**BEFORE THE PUBLIC UTILITIES COMMISSION  
OF THE STATE OF CALIFORNIA**

**MUSSEY GRADE ROAD ALLIANCE COMMENTS  
ON THE DRAFT GUIDELINES FOR THE 10-YEAR ELECTRICAL  
UNDERGROUNDING DISTRIBUTION INFRASTRUCTURE PLAN**

Dated: May 29, 2024

**Figure 1** - Cost per avoided PPS minute for each grid segment in the SDG&E 2023 undergrounding program. The scale is logarithmic.

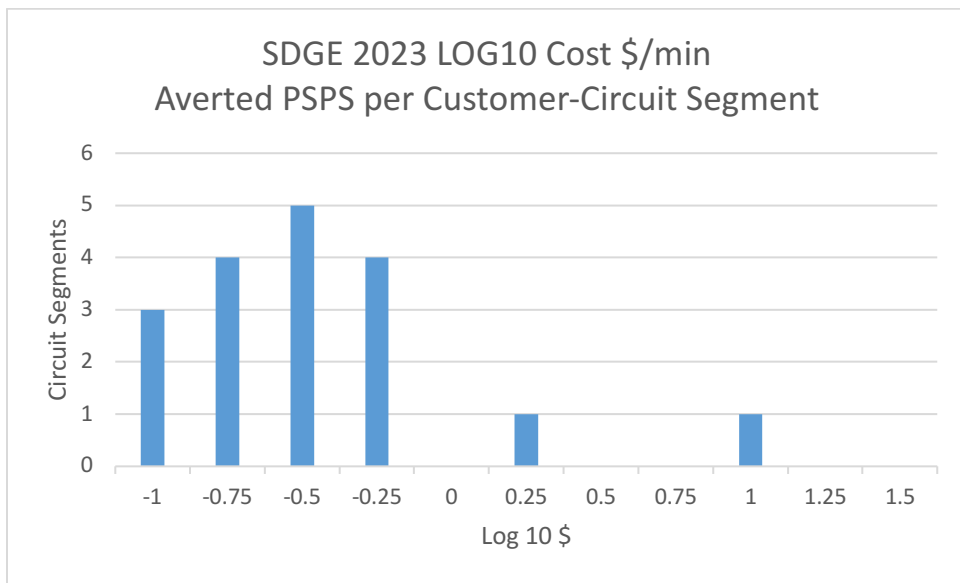
As is shown in Figure 1, the cost to avoid a customer PSPS minute varies widely between circuits with a range of two orders of magnitude (from ~\$.01 to \$10)

**Figure 3** - Cost per avoided PSPS minute for each grid segment in the PG&E 2023 undergrounding program. The scale is logarithmic.

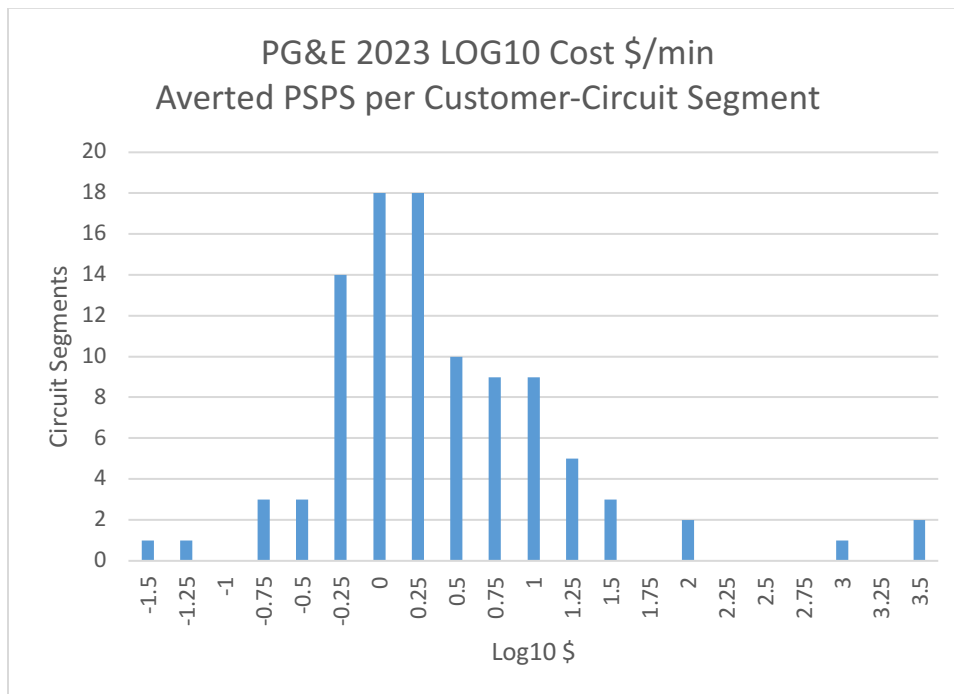
As is evident, the cost to reduce a PSPS-minute in the PG&E territory varies much more than that in the SDG&E territory: by five orders of magnitude (a few cents to a few thousand dollars).

**Figure 4** - Cost per avoided PSPS minute for each grid segment in the planned PG&E undergrounding program through 2025. The scale is logarithmic.

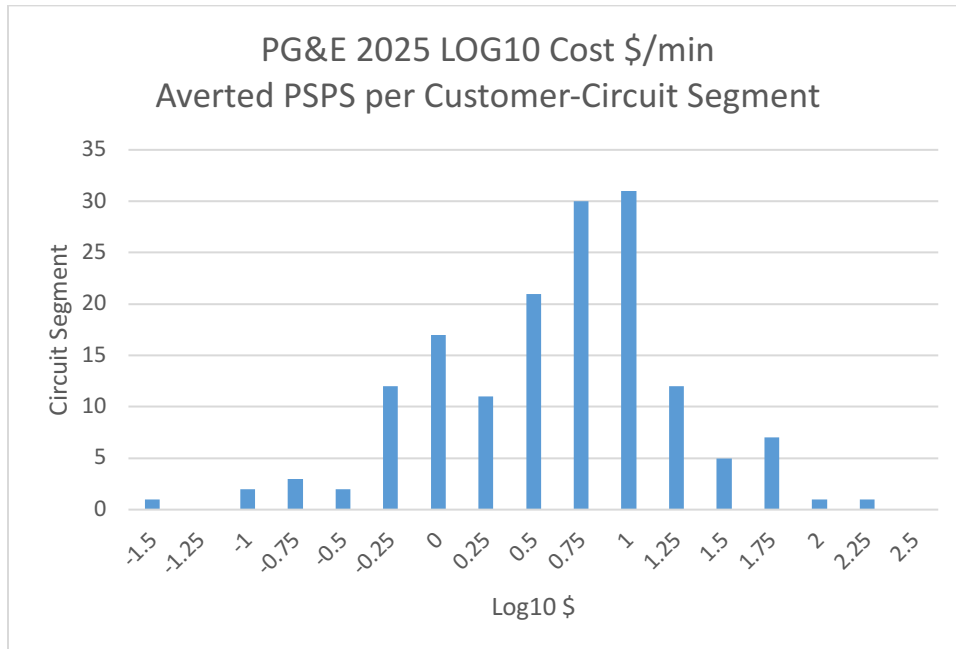
Note that PG&E's undergrounding program through 2025 will cost roughly 10 times more per customer PSPS minute averted than the undergrounding work that PG&E has already completed.
